August 3, 1984

HOPE CREEK GENERATING STATION  
DOCKET NO. 50-354  
DRAFT SAFETY EVALUATION REPORT  
OPEN ITEM STATUS

In addition, enclosed for your review and approval (see Attachment 4) are the resolutions to the Draft SER open items, FSAR question responses and structural geotechnical audit item responses, listed in Attachment 3.

FIGURE 9

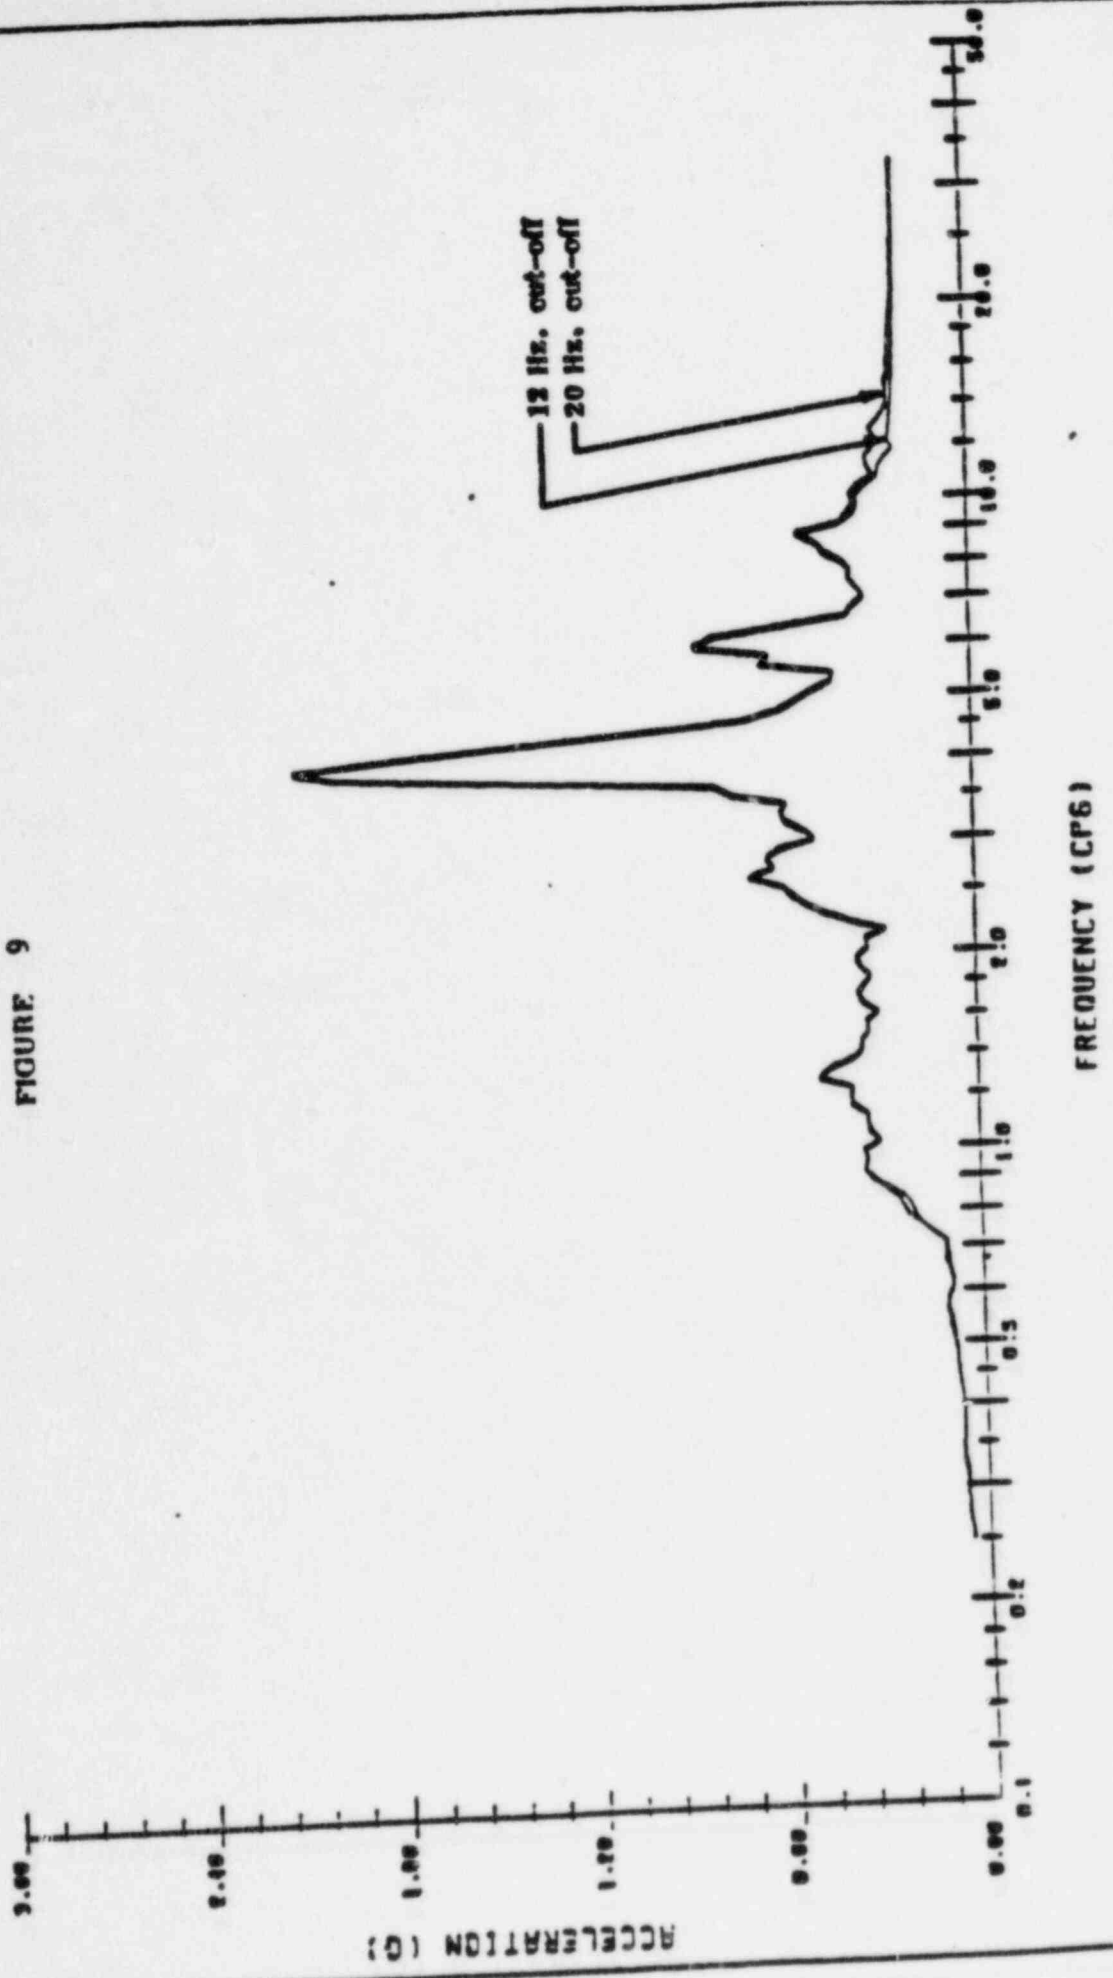
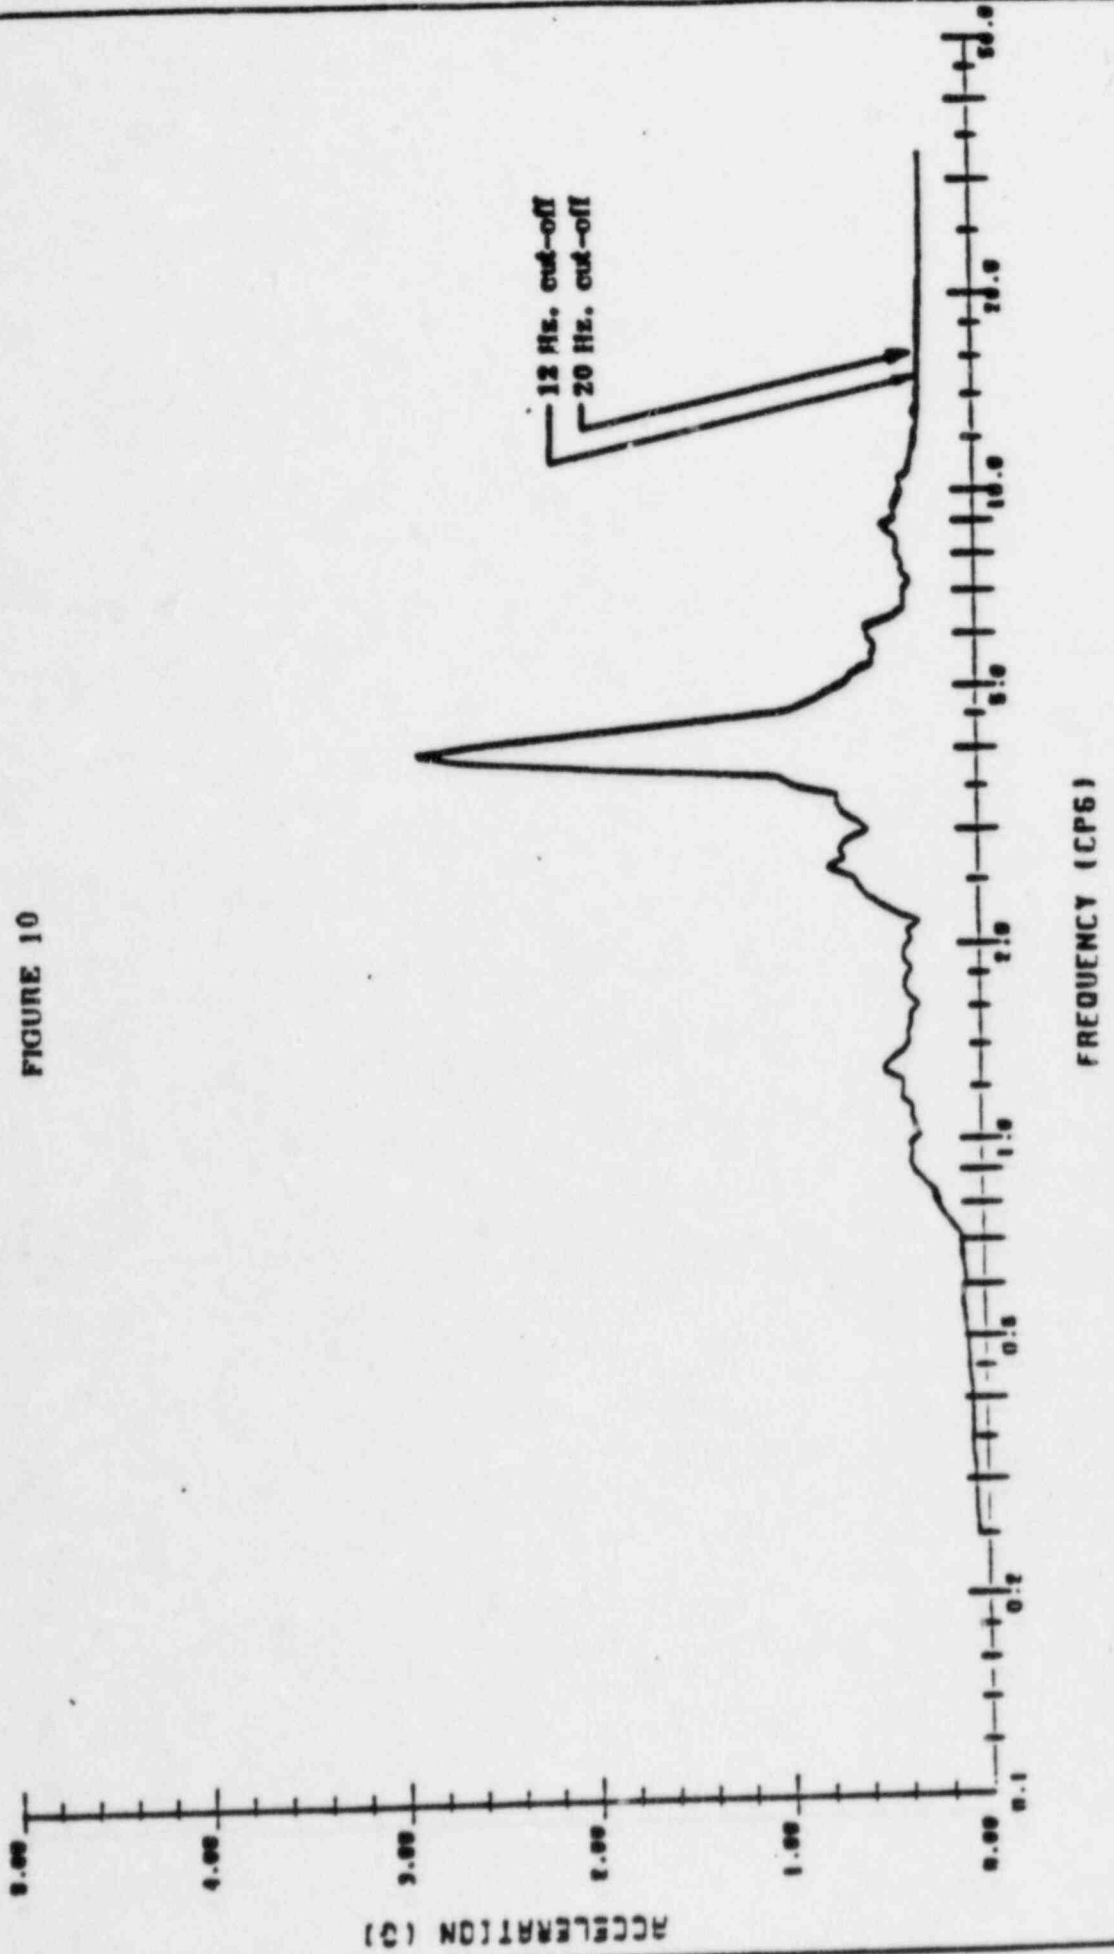
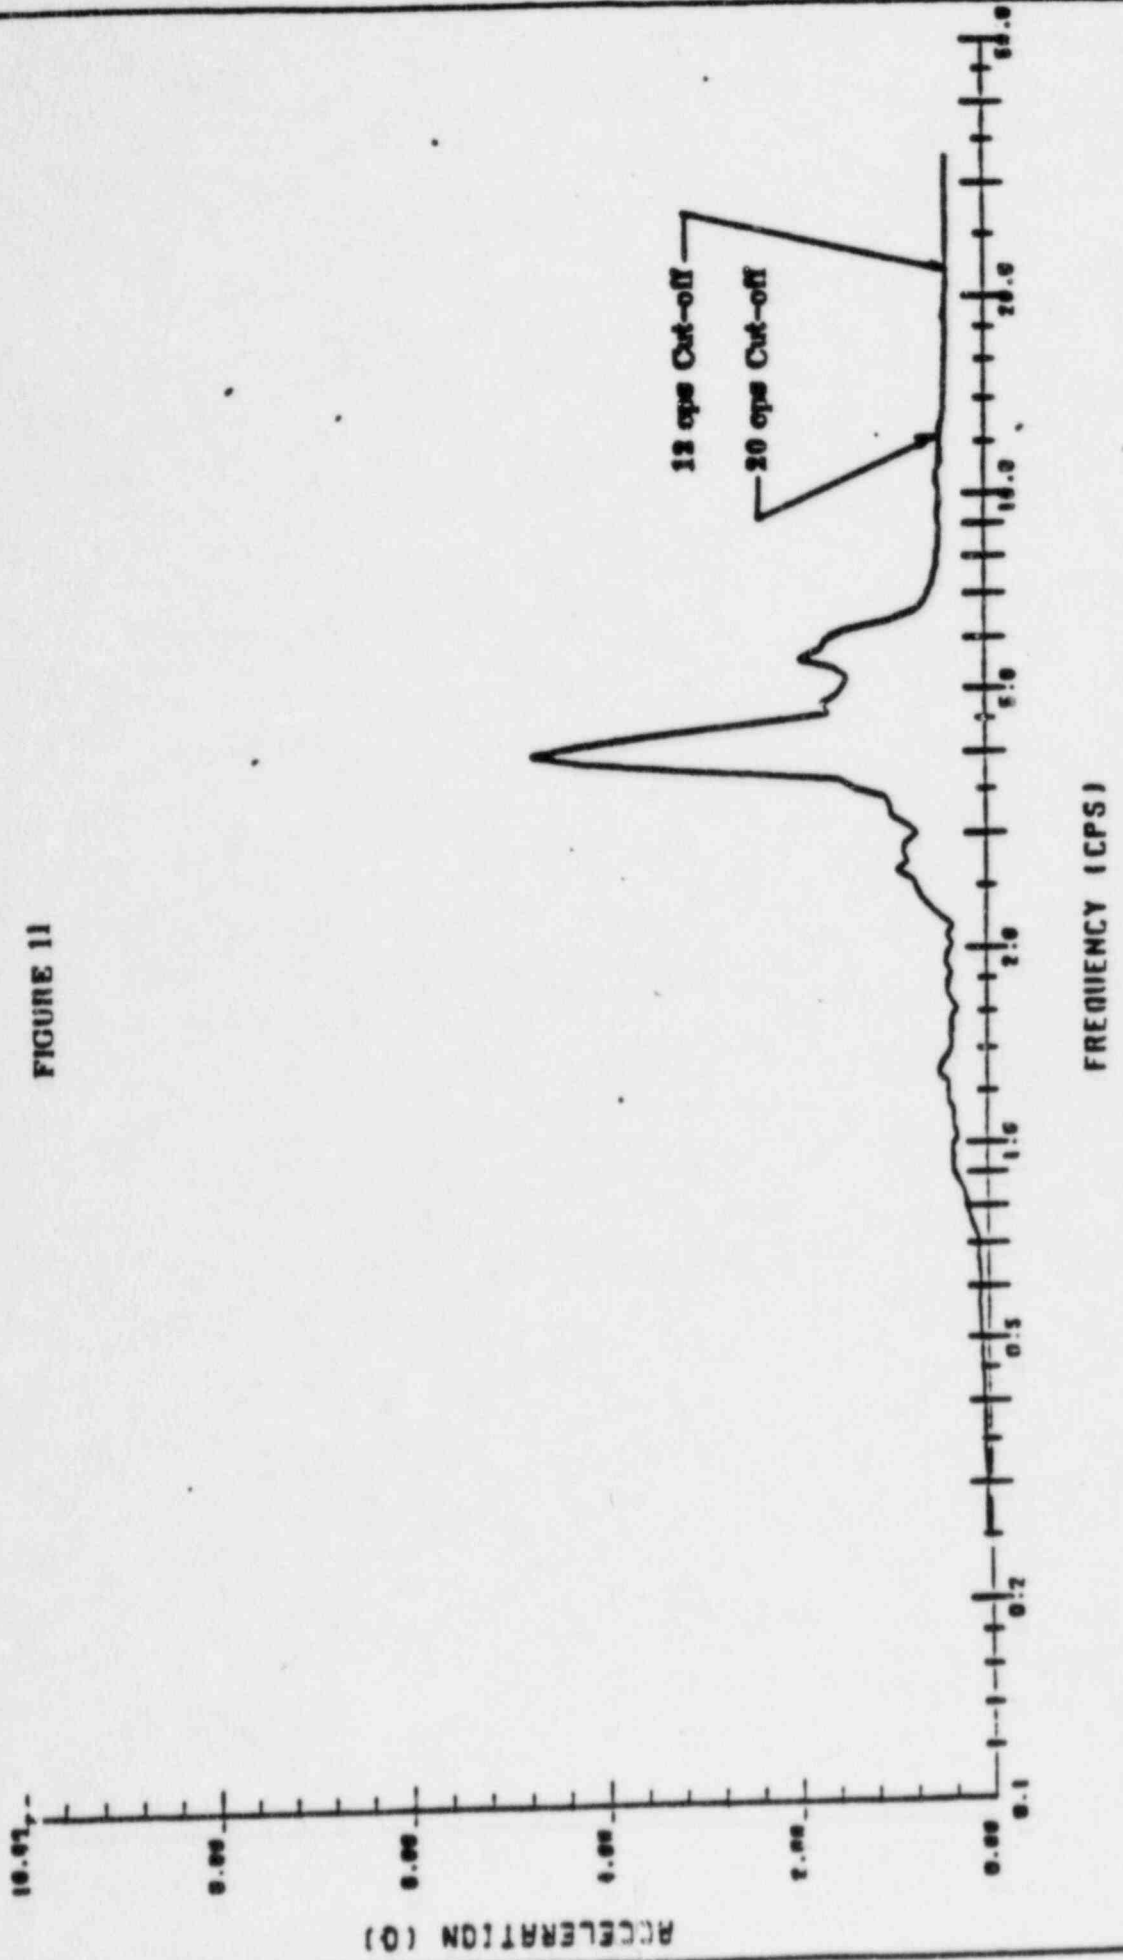
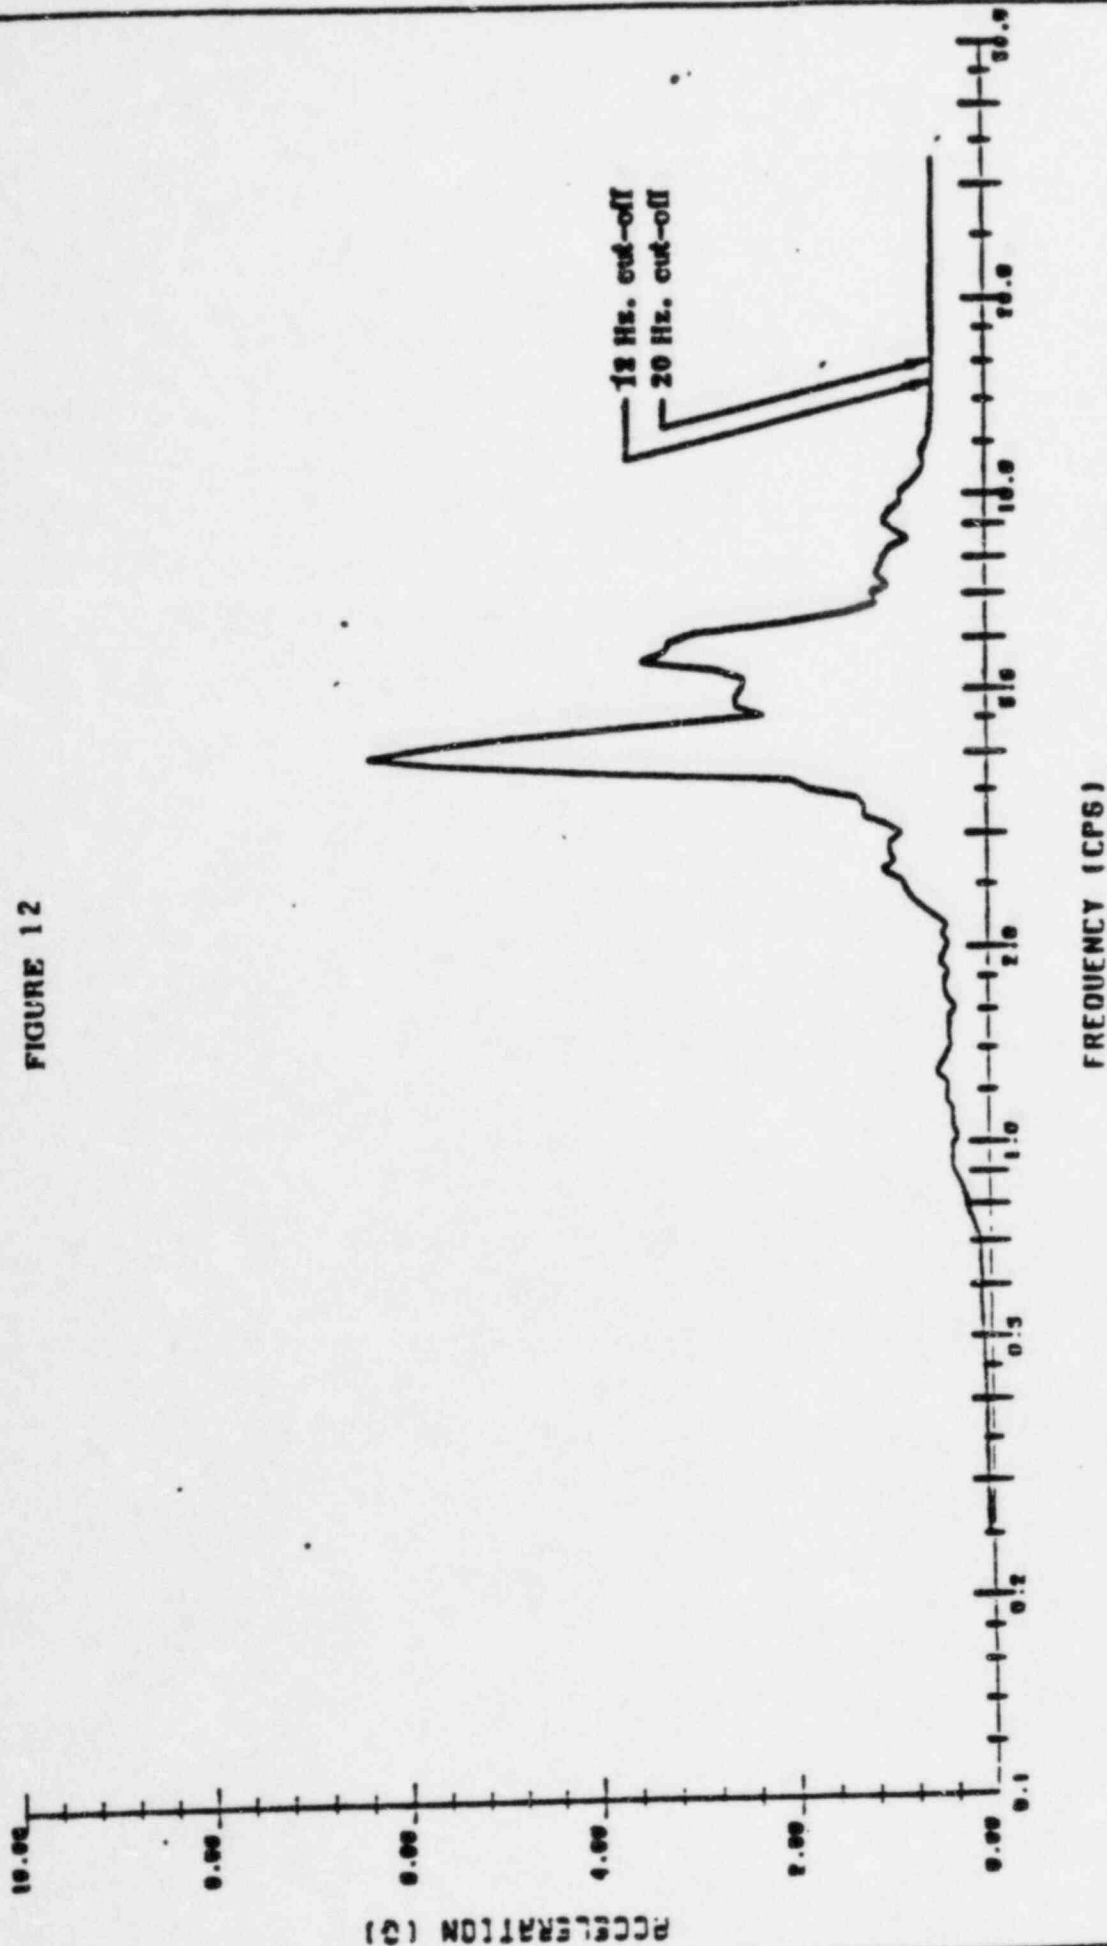
A soil column, representing the Hope Creek free-field soil properties, was first constructed. The mesh refinement was selected such that a wave frequency of 20 Hz. could be transmitted without loss of numerical accuracy. A schematic representation of the soil column model is presented in Figure 1.

Response spectra plots at various elevations of the Reactor Building are presented in Figure 9 through 12. As can be seen from these figures, the spectral accelerations in the low and mid frequency range are essentially identical for the two cut-off frequencies. In the frequency range above 12 Hz., there are minor differences at the lower elevations of the Reactor Building, but almost no variation in the upper elevations. However, these minor differences are considered to have no significance on global structural response. For all elevations, the overall trend of the curves is identical, duplicating peak response values and shape of the spectral curves.
